From: Simon Greenland
Sent: 24 February 2012 08:54
To: planning_admin
Subject: P/2011/0891 Bryn Lane

From: Phil Palmer
Sent: 23 February 2012 17:56
To: Tim McLoughlin
Cc: Simon Greenland
Subject: RE: Bryn Lane

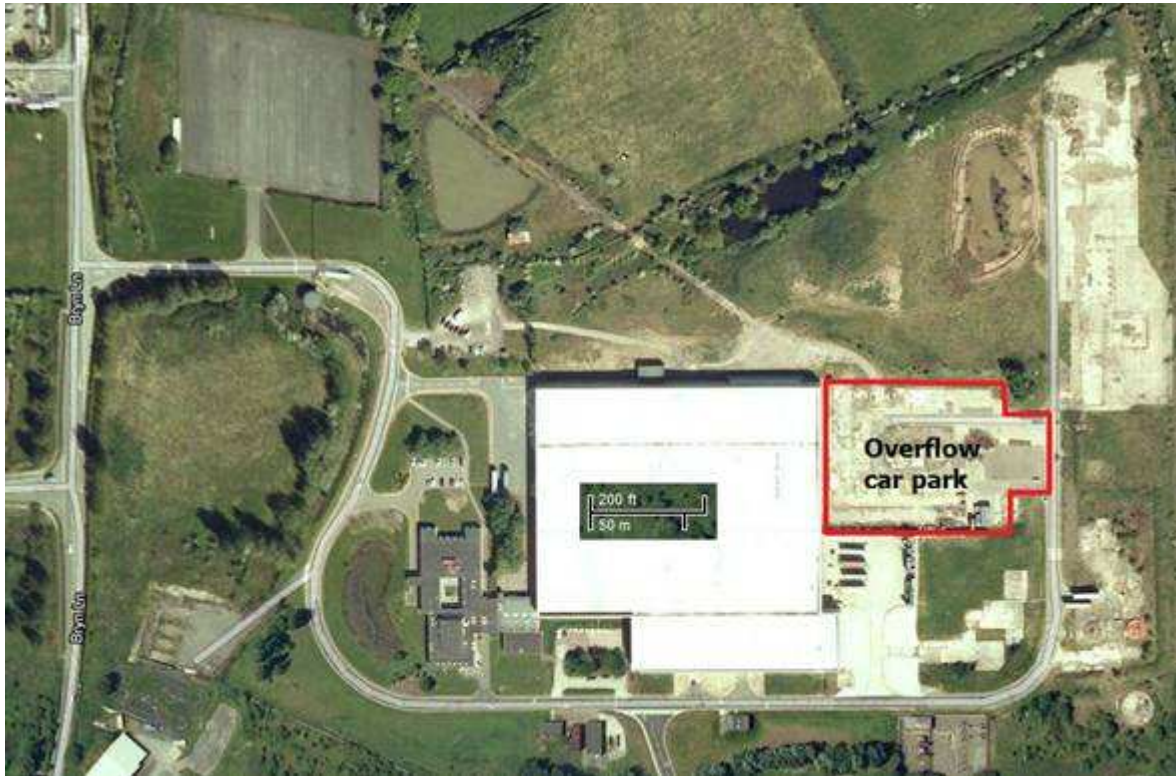
2. I have visited the proposed overspill car park. It would need levelling / re-surfacing to be used as a car park but would appear capable of accommodating the number of cars you suggest.

I assume if you are reducing the footprint of the development you will be providing a new scaled layout plan for assessment. Although providing 271 spaces at the site and 100 spaces at the overflow car park sounds ok in theory (subject to staff being transported by bus to the main building), I understand that it may be not be feasible to provide 271 spaces at the development site for ecology reasons. I assume the overflow car park would have to be provided / dedicated to the development site in perpetuity for any future occupants of the site. Can you confirm ?

2. The parking for this development comprises new spaces and the use of the area shown below for overflow parking. This area is not marked out for specific car spaces but is large and will easily accommodate 100 cars. [Note formally marked out it would accommodate over 350 spaces.]

The applicant intends to operate a shuttle bus from this car park to the new building. The WCBC standard is 1 space per 100ms gross floor area. The building footprint is being reduced from the original submission and the WCBC standard equates to 371 spaces (exact floor area is to be confirmed). Would you be happy with 271 spaces at the new site and the 100 spaces in the overflow car park identified above?
